2022 D-9/ ASHE WORKSHOP

JOINT MGMT/ IIC COUNCIL QUALITY EFFORT

To identify focus areas where the potential for quality improvements may exist that would provide mutual benefit to both Design and Construction

EXAMPLE #3 (cont.)

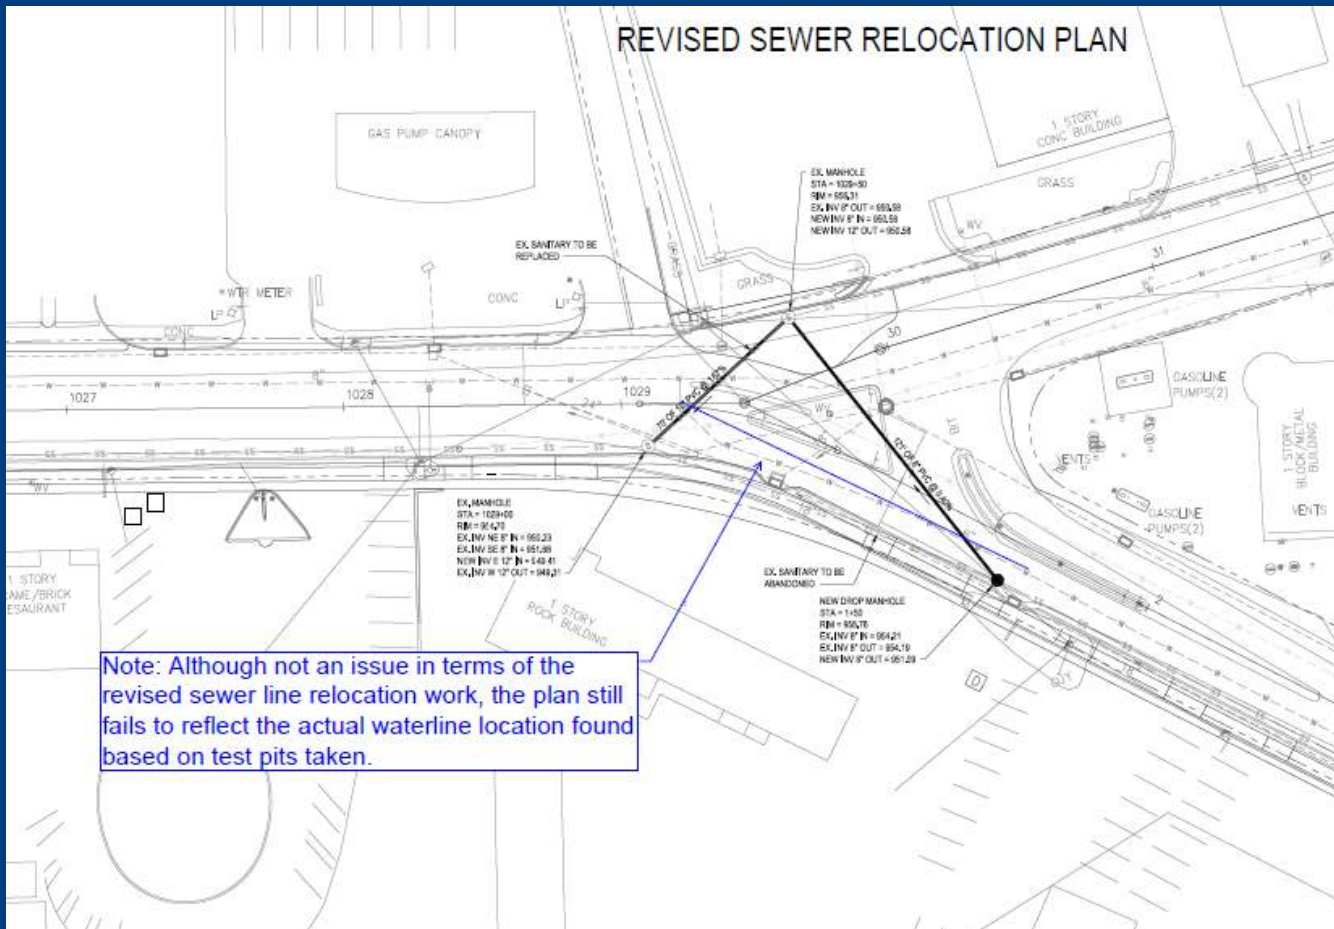
- In addition, municipality noted that the location of the existing water line as shown may not be correct due to relocation work completed the prior season
- Test holes were taken and verified the water line was incorrectly shown and, as a result, would be in conflict with the new proposed sewer manhole
- Complete re-design of sewer relocation would be required

EXAMPLE #4

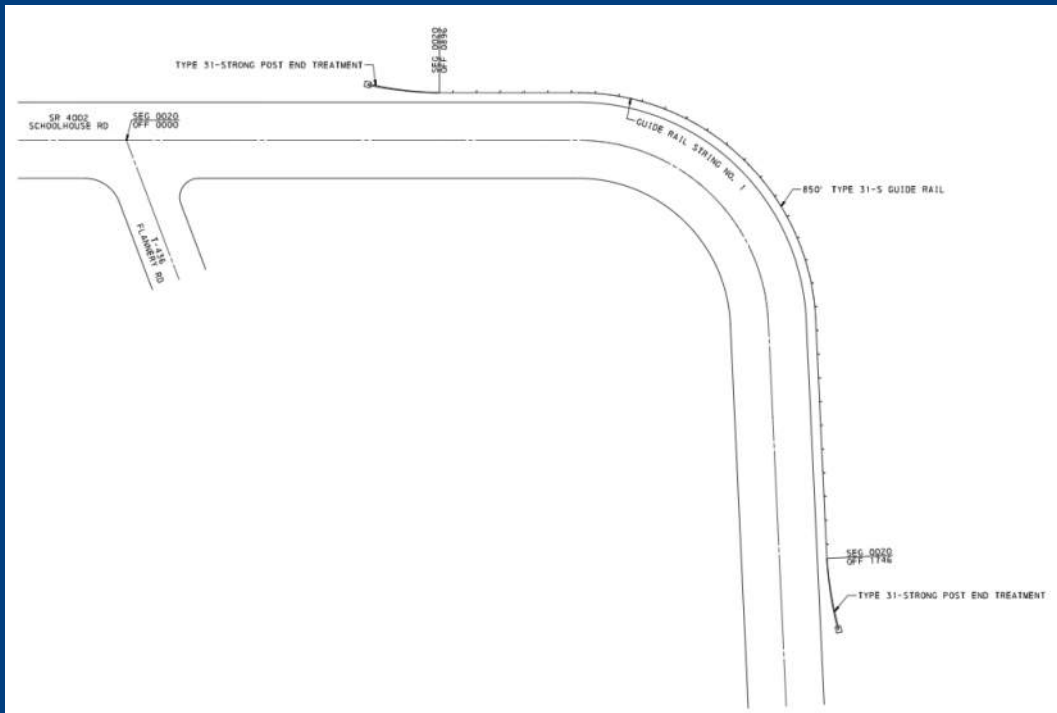
- New Type 31-S guiderail depicted around curve
- No utilities depicted on plan
- In reality, several overhead utility poles were located along the run
- Along with requiring string realignment (to <2' from shoulder edge in some areas), added Type 31-SC and 31-SCC for proper deflection

EXAMPLE #5

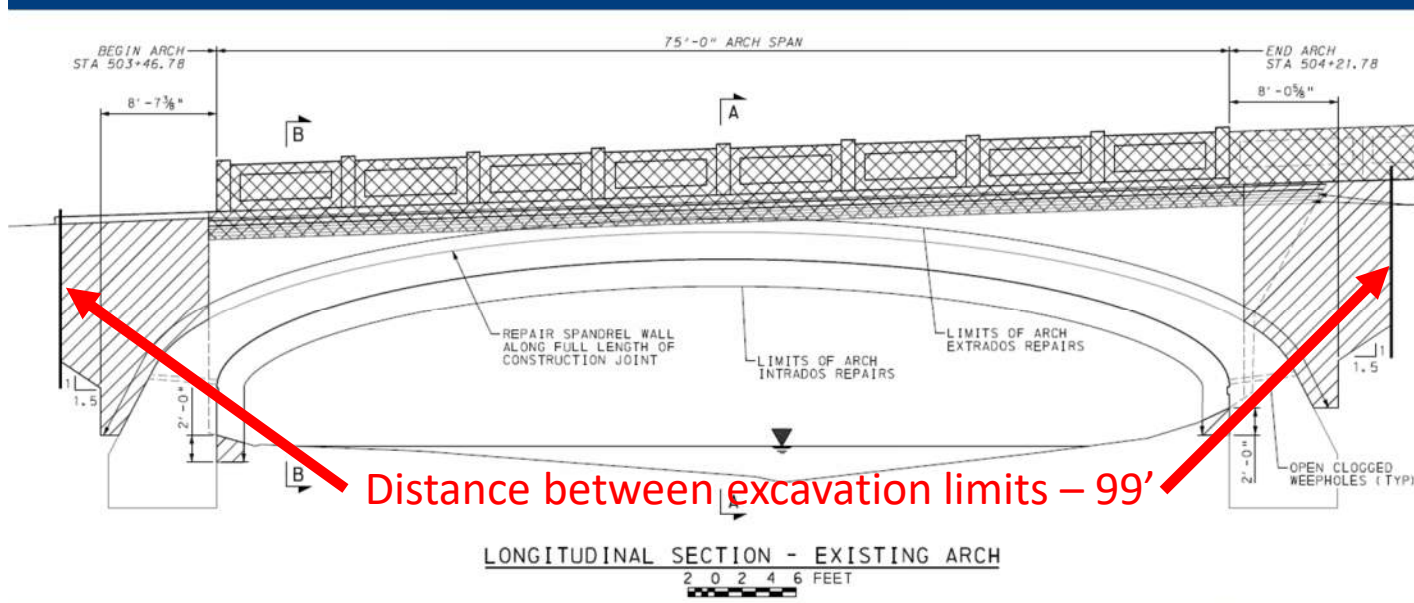
- Temporary support beam for Verizon line was designed at 105'
- Distance between excavation limits was 99'
- Taking the width of the shoring and holes into consideration, leaves 1.5' of space behind the shoring to set the footing for the support platform

EXAMPLE #5 (cont.)

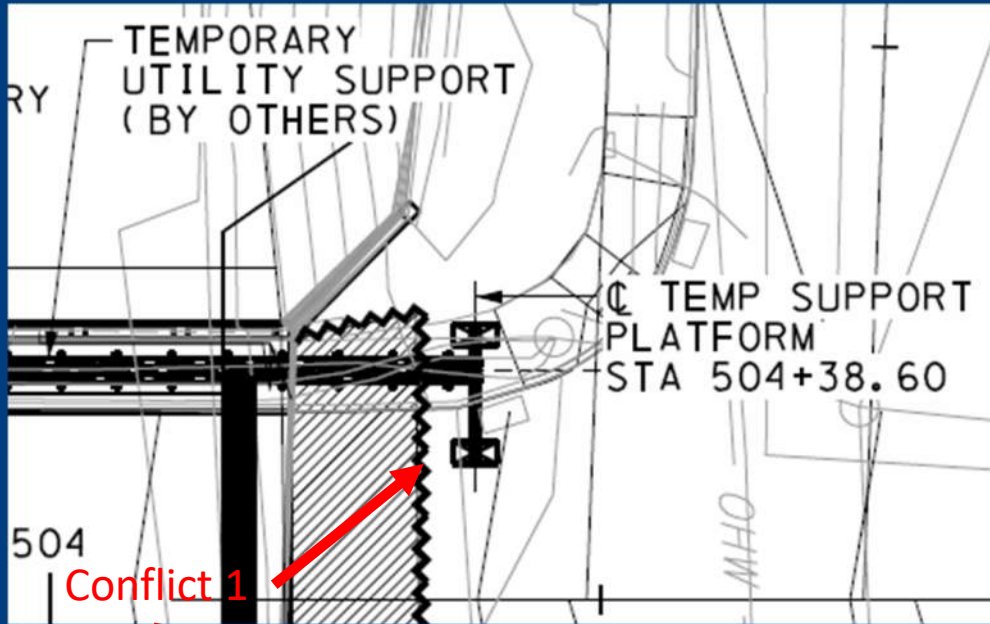
- Footing support platforms were 4' long
- Conflict 1: The footing support platform would be on top of the shoring
- Conflict 2: The footing support platform would be in the same location as the access point for the Verizon Conduit
- END RESULT: Verizon needed to order a longer beam. That combined with constructability complications and the temporary support operation added a month delay to the project.

EXAMPLE #1

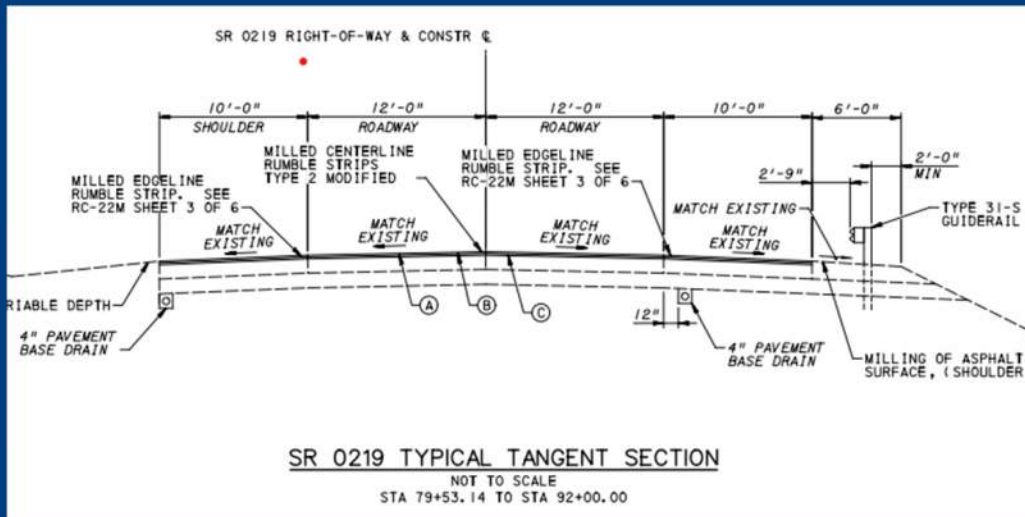
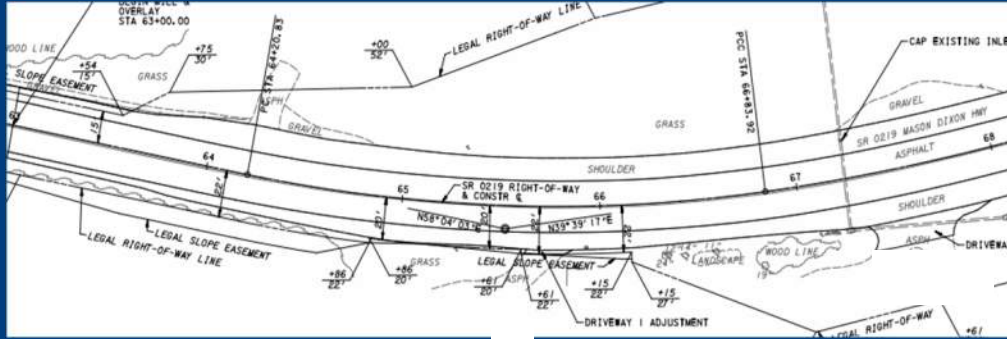
- Typical Cross Section shows shoulder widths vary 3' to 10' from Sta 63+00 to 79+53.14

- Typical Cross Section shows shoulder widths are 10' from Sta. 79+53.14 to 92+00

- Plan Sheets Show 10' (scaled) shoulders starting about Sta 64+00 Left and 67+25 Right
- Design calculations assumed two 5' shoulders from Sta 63+00 to 92+00 causing significant quantity overruns
- Actual Wearing Course, Leveling Course, Tack, and Milling quantities were roughly double the plan quantities

EXAMPLE #2

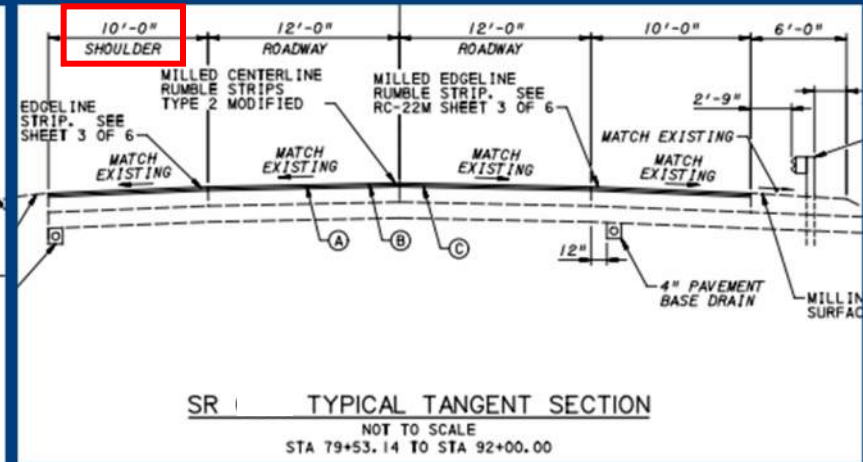
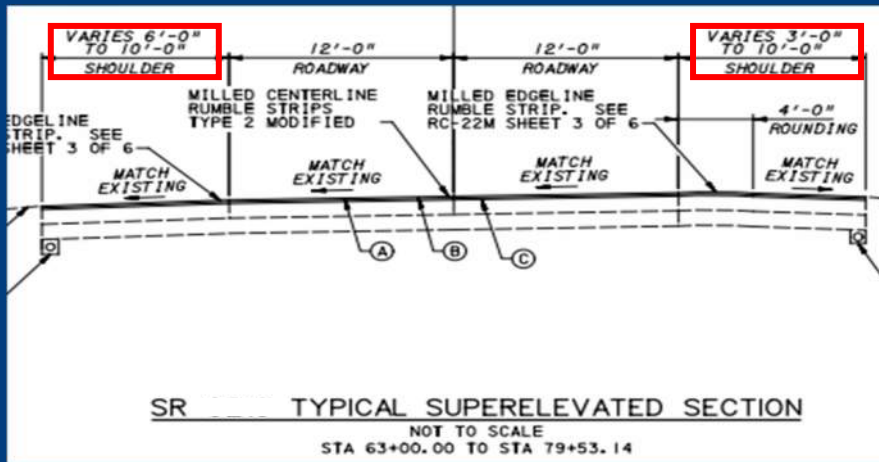
- Milling called out as 2 1/2" depth on Cross Section but tabbed as 1 1/2" depth

EXAMPLE #2

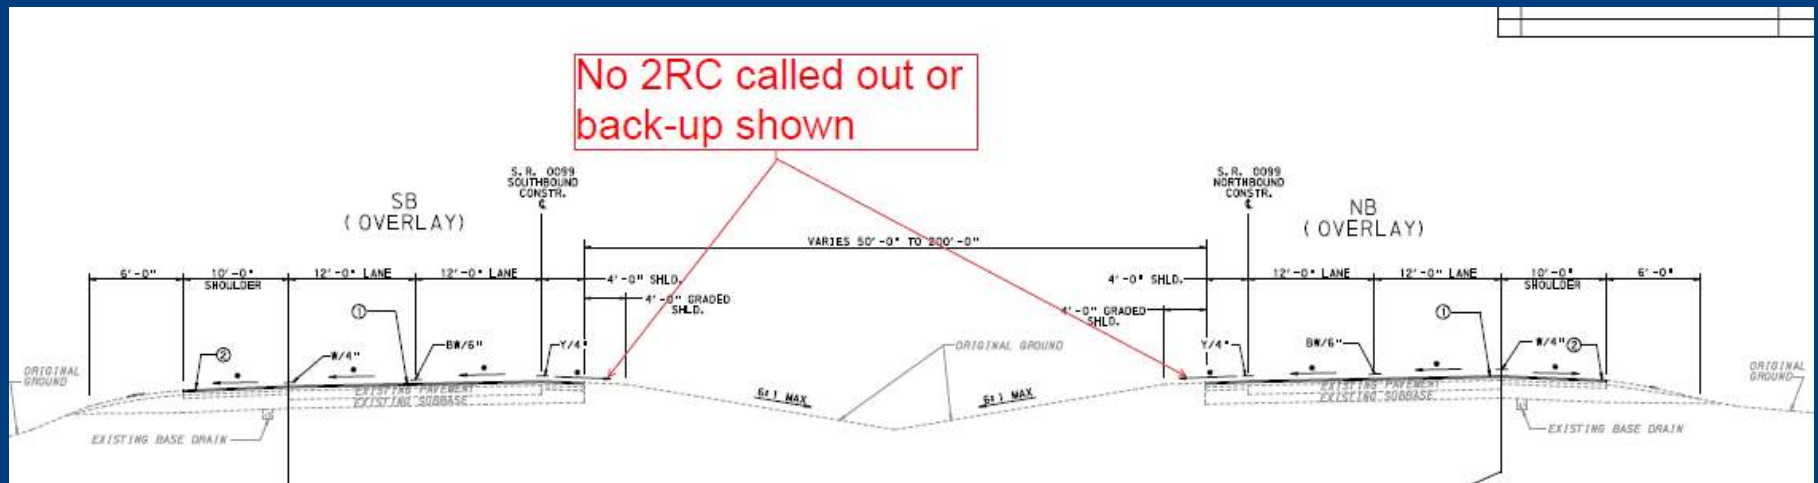
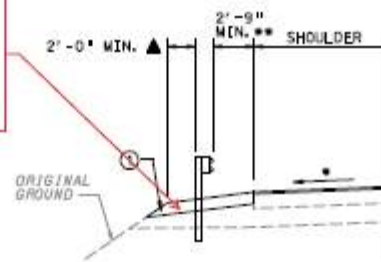
- Project scope was for 1" thin lift overlay of four-lane
- No shoulder back-up was shown in median areas or included in back-up quantity computations
- Additional quantity of 2RC back-up added via work order at a cost of \$131K

Only location
2RC was called
out or tabbed
(guiderail areas)

EXAMPLE #3

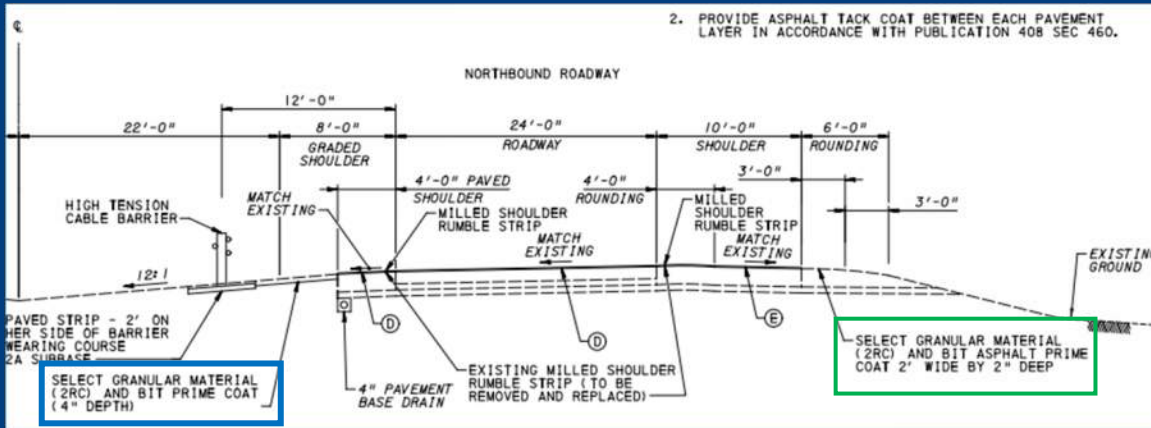
- The designers' methodology (refer to green areas) state 2RC areas were calculated at 2' width and 6" depth. However, cross sections show areas are typically 2' wide and 2" depth except at the HTCB (4' width and 4" depth)
- Plan 2RC quantity is 1331 tons while the designer calculations are for 1100 tons (missing designer calculations for 231 tons ~ was this an arbitrary % increase?)
- No 2RC, Class 1 Excavation, or Prime Coat quantities were provided for areas between the paved shoulder and HTCB (refer to blue box)
- Calculations have a 'Computed By' date of 7/1/20, and a 'Checked By' date of 2/24/20
- \$276K in work orders required for areas missed and incorrect calculation assumptions (including 2RC, Prime Coat, and Class 1)

Assumptions 2' wide by 6" deep

EXAMPLE #2

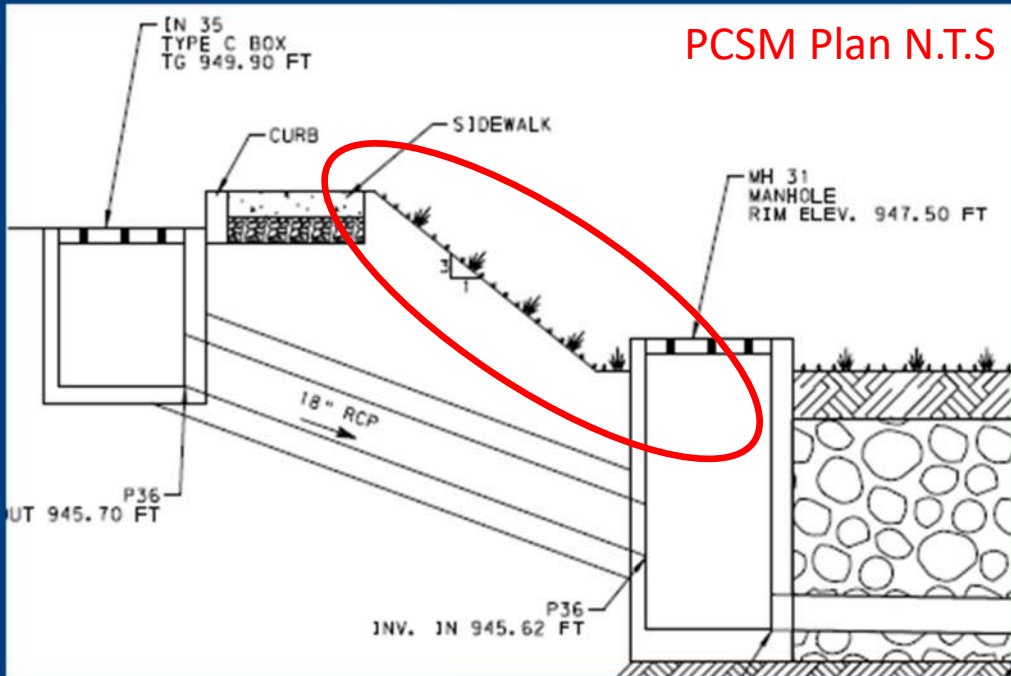
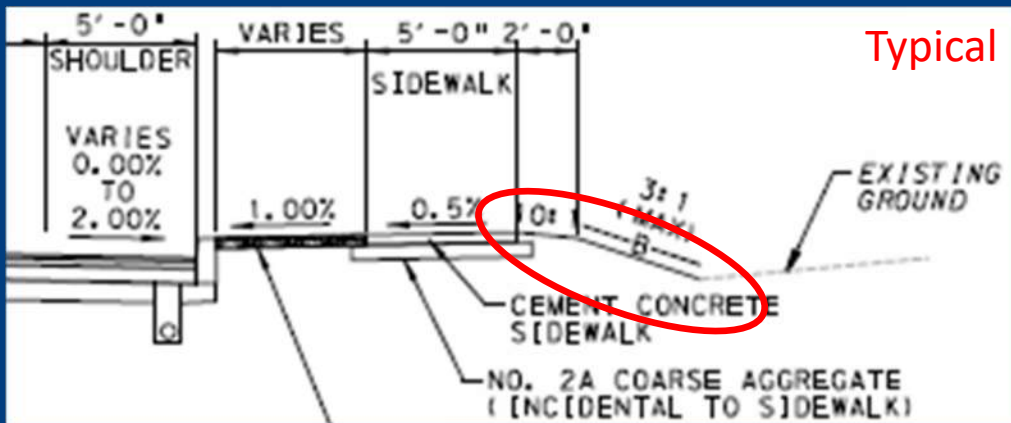
- This same area is depicted on three different plans and none are matching
- The PCSM Plan is not to scale, but does not appear to show a 2 foot flat area beyond the sidewalk
- The Typical shows the 2 foot flat area but does not show the pond

EXAMPLE #2 (cont.)

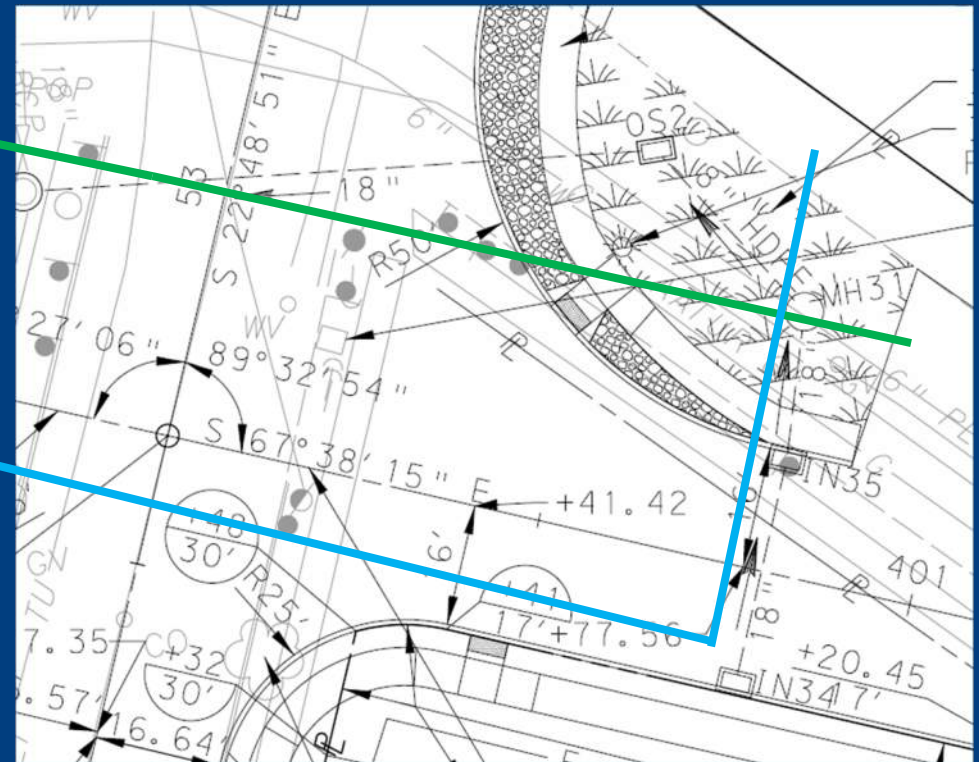
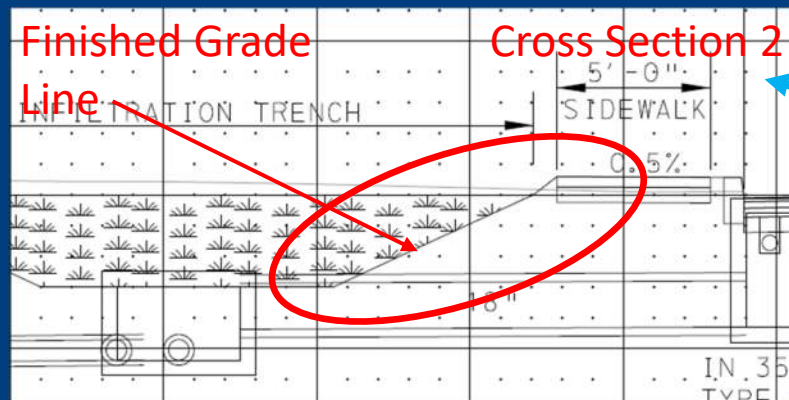
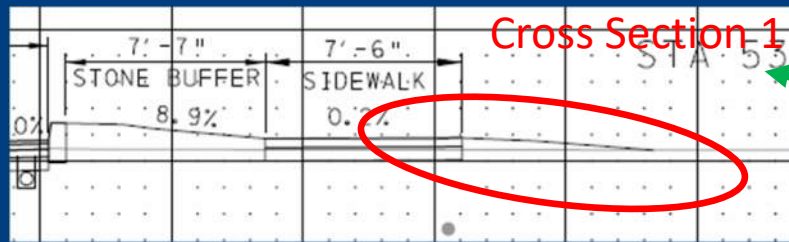
- This area is near two intersecting roads, so the area is covered on multiple cross sections
- The cross sections are what is used to build the project and do not show the 2 foot flat area. One shows a flatter downslope and does not show the pond.
- Ultimately, a majority of the sidewalk was shifted away from the pond in order to be able to maintain a 2 foot flat area. Without the flat area, it would be a direct slope from the edge of the sidewalk into the pond.

EXAMPLE #3

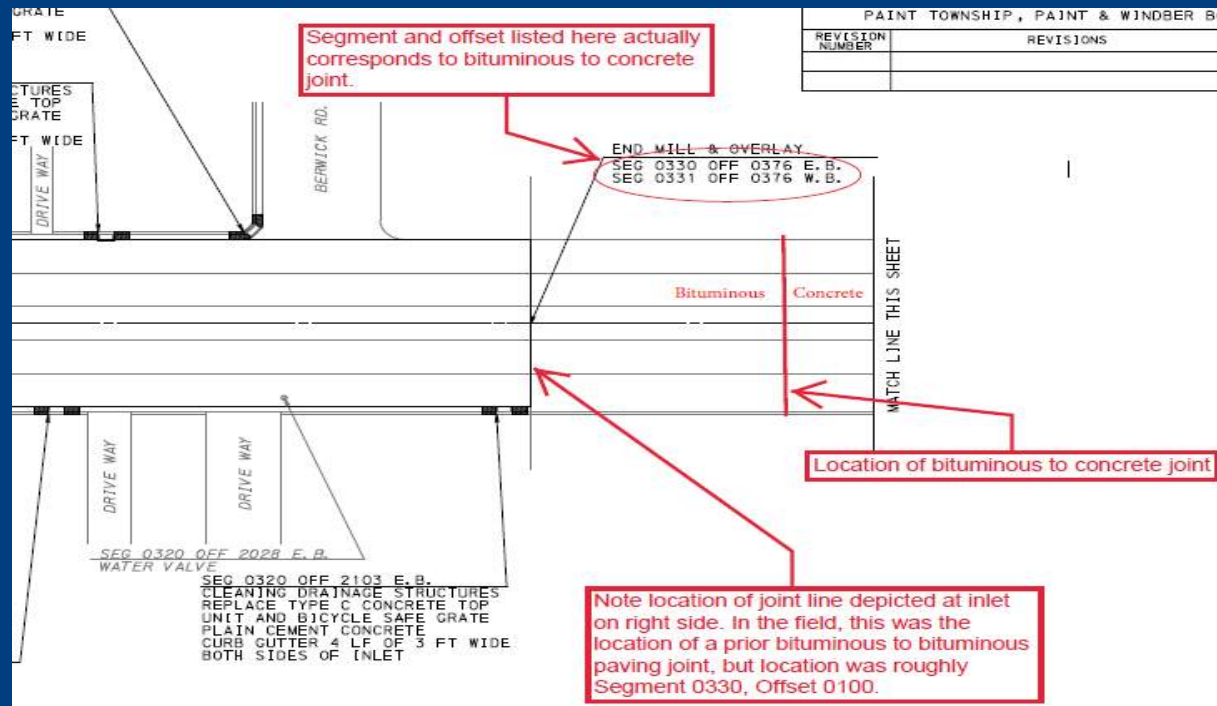
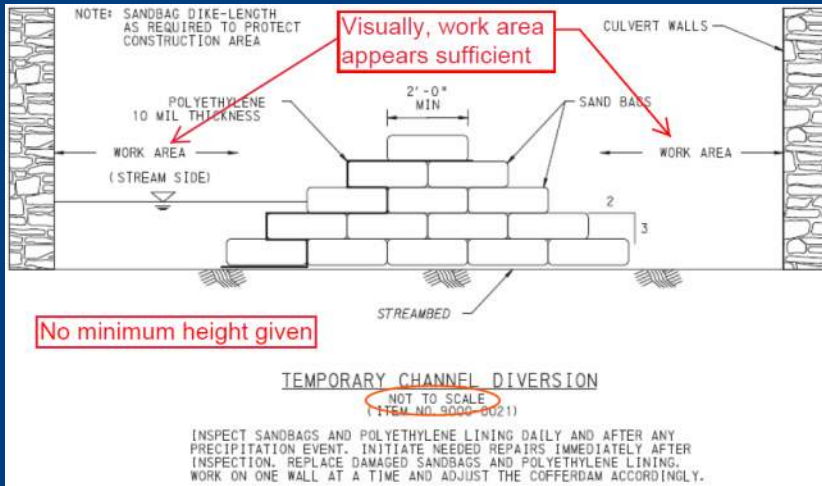
- Not to scale plan view appears to show end of mill and overlay corresponding to prior bituminous paving joint
- Intent, however, was to pave to concrete joint
- Contractor laid out to bituminous joint and left roughly 276' of old bituminous
- Not discovered until final inspection
- Although segment and offset were correct, contractor argued the plan was misleading due to location of joint at inlet and presence of prior bituminous joint
- Based on potential exposure for claim, required work order to pave remaining 276' costing \$59K (including remob)
